Safety Minutes of Radiation Safety Committee of August 10, 2006

Subject: ERL Critical Devices, Klystron Room, and Fault Protection

Safety Minutes of Radiation Safety Committee of January 18, 2007

Figure 2: Dose per electron at radii of 290 cm and 320 cm. The roof transition occurs at z=200.

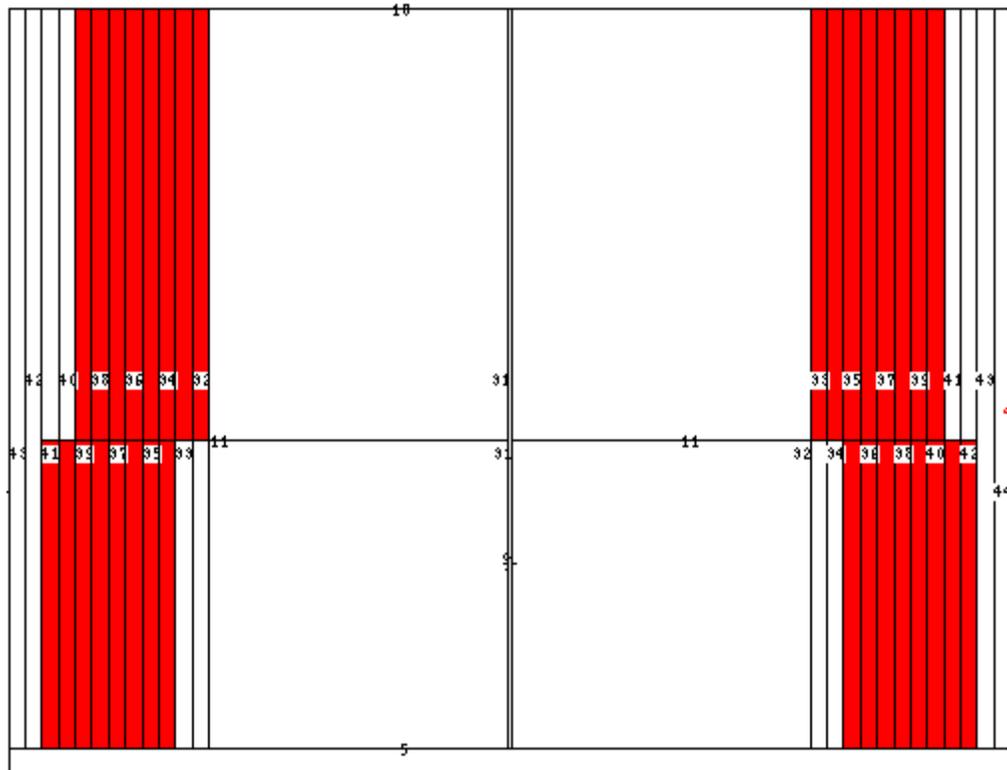
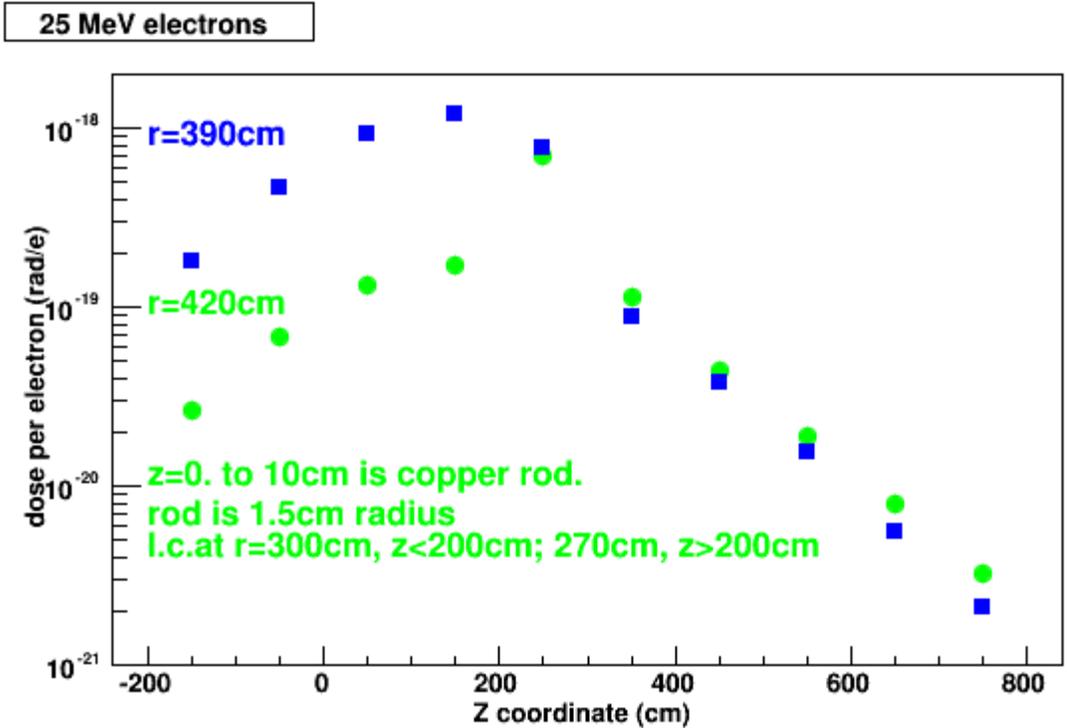
The initial design of the ERL roof was at a fixed height of 13 feet above the floor. To aid in rigging operations the central section of the roof was raised to 14 feet forming a transition at both end of the area. To examine the impact of this change on radiation dose through the roof a simple model was used in MCNPX¹.

The dose rate through the roof and at the transition is dependent on the beam power on the target. Ten Watts of beam power corresponds to 9×10^{16} and 9×10^{15} e/hr for energies 2.5 MeV and 25 MeV, respectively. Point detectors were also used in the analysis and were used to get a slightly higher dose than the flux average over a distance of a meter. The dose rates near the transition for 10 Watts of electron beam are 0.006 mrem/hr and 7.1 mrem/hr for energies of 2.5 MeV and 25 MeV respectively. Access to the roof is not allowed when the Gun or Five-Cell Cavity are being operated. There are some large cracks between the roof beams that form the roof. The dose rates out these cracks could be as high as 1.1 rem/hr (2.5 MeV) and 5.8 rem/hr (25 MeV) if the entire source can shine directly through the crack. Although the actual dose rates are expected to be smaller and not represent whole body exposure they are still a serious concern if personnel access the roof.

The roof transition appears to produce a localized elevated dose rate consistent with three feet of effective shielding. The dose rates for the 10W test are not an issue for the transition. The radiation hazards from other weaknesses such as the cracks or the roof ODH vent are probably more relevant concerns if someone accesses the roof. For higher power tests in the future it will be important to correlate the dose rates at the chipmunks to the dose rate on the roof including the weak locations.

Figure: Plan view of shield and dump area, drawing 010606213.

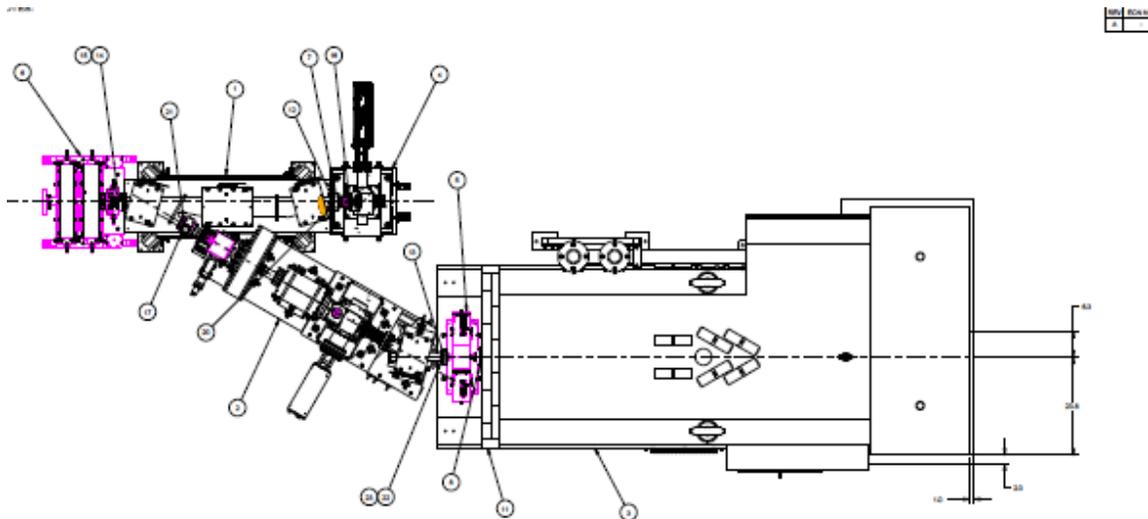
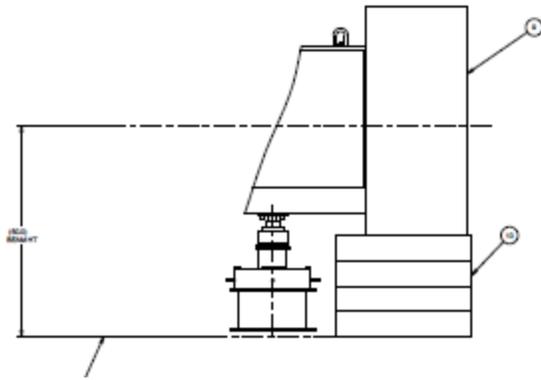
There is a steel shield between the dipole and the beam dump. The original purpose of this shield was to provide for equipment protection from the back-shine from the beam dump. However, portions of the beam dump are struck by electrons that are at the same elevation as the horizontal seams in the concrete wall. The x-ray transmission through the seams is very sensitivity to the source elevation. In addition, the analysis of interlocks and faults has not been completed for the transport at and beyond the first dipole. An incorrect set-point of the last dipole or if the magnet turns off will cause the beam will strike the Pb shield. It was decided that the Pb shield should be considered as area shielding and the prints for the Pb shield be upgraded to QA-1.

The project would like to change the design of the end steel. A cast-iron B block will be centered about the beam dump in both vertical and horizontal directions. This will eliminate in the shield materials near beam height. The final design needs to consider whether the cast-iron B block needs shielding on top. It was noted that the block serves to shadow the labyrinth wall from both losses in the beam lines and from the radiation generated in the beam dump.

1. Update appropriate prints to QA-1 including the Pb shielding
2. Band and post the Pb shield.
3. Archive the results of the Pb analysis
4. Modify plug and attach both
5. Finalize end shielding design
6. Determine configuration past first dump dipole and analyze.

Figure II: The simple model of the two concrete walls and the walkway between them. The 2.54 cm seam is between surfaces 56 and 57. The dose was scored at surfaces and with point detectors.

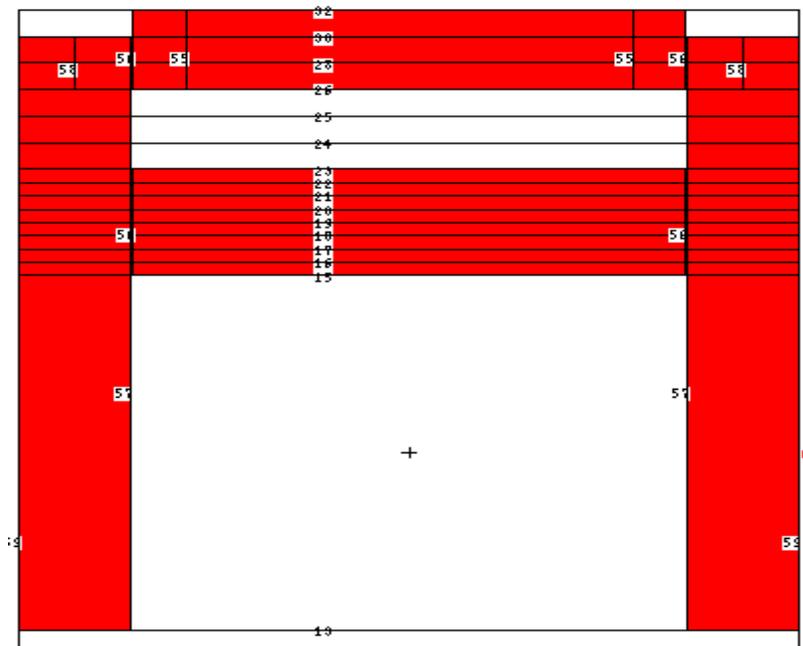
A flange of 1cm thick copper was used to approximate the electron beam striking an object. The flange was located at the end of the five-cell cavity with a distance to the first wall of the labyrinth of 540 cm. The geometry is shown in Figure 2. The concrete roof before the labyrinth is included in the simulation. The concrete roof ends half way over the second end wall forming a ledge. Water pipes are run along this ledge as well as cable tray supports.

A 3.5 MeV electron beam was directed at the center of the flange. At the edge of the concrete end wall the photon dose per electron is 3.2×10^{-20} rads/e. 100 Watts of beam corresponds to 6.44×10^{17} e/hr. The dose rate for the beam striking the flange is 21 mrad/hr. The dose rate is sensitive to the flange thickness. If the flange is changed to a thickness of 0.1 cm then the dose rate for photons increases to 110 mrad/hr. The dose from electrons can be ten times higher for thin objects if there is no material to absorb the electrons that are scattered. The calculations were repeated for the flange located at a position that simulates the Faraday cup that will be used in the first beam test location. In this case the flange is 1200 cm from the first labyrinth wall. The dose rates are a factor of two smaller than the results for the flange downstream of the five-cell cavity. A layer of Pb has been placed along the outer crack on the ledge to reduce the dose rates.

The effectiveness of the Pb can be estimated using published TVLs. The Pb bricks placed along the seam will be 5 cm high and 10 cm thick. Using a TVL of 3.5 cm provides an attenuation² of 1.5×10^{-3} for 10cm of Pb. The Pb will completely remove the electrons that are scattered from thin targets. For 100 Watts of 3.5 MeV beam the dose rate at the side wall is reduced to 0.1 mrem/hr. The estimated attenuation is expected to be conservative. A source of uniform photon fluence with fixed-energy was used as a second

Figure IV: Pb shielding covering the entrance of the laser port inside the ERL shielding. The Al spacer does not shield the bored hole. The one inch diameter laser pipe is not shown.

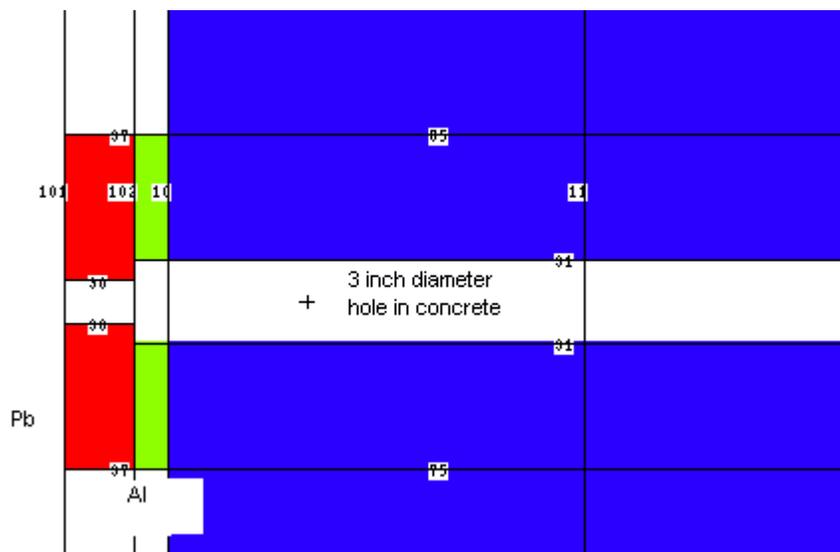
The laser port was originally a rectangular port with dimensions 3 by 4 inches. The port was shadowed by the shielding¹⁰ for the one megawatt waveguide. It became desirable to have the laser port in another location so a 3 inch diameter hole was bored through the shielding at a location approximately transverse to the first beam halo scrapers. The dose rate out the original laser port was estimated assuming that the port was shadowed by approximately two feet of heavy concrete. The new laser port is not shadowed for beam losses in the upstream transport. The dose rates out the laser port have been estimated using MCNPX in two stages. The first calculation provided the energy distribution and dose for electrons and photons. These distributions were binned in energy and then used as a source input in MCNPX. The source directed photons and electrons onto the area of the port based for the existing geometry. The simple model¹¹ of the shield wall with the Al spacer and the 1 inch lead shield is shown in Figure IV.

The calculation used the 0.1 cm diameter rod on the beam line 255 cm away from east side wall and 137 cm above the port. For 100 Watts of 3.5 MeV electrons the dose immediately outside the port is 14 mrads/hr. At a distance of one foot from the wall the dose rate is 10 mrads/hr. Beam faults with beam power of 1000 Watts are not expected to be sustainable although this assertion has not been proven. If necessary additional shielding can be placed inside the ERL enclosure if the laser pipe valve is moved. The old laser port has some critical length cables being routed to equipment and cannot be completely plugged. The Faraday cup for the first beam test has two feet of heavy concrete between it and the new laser port. The first halo scrapper has no shielding between it and the new laser port and will be used for a fault study if possible. The halo scrapers will be locked in the open position until the machine is ready to conduct fault studies on the scrapper.
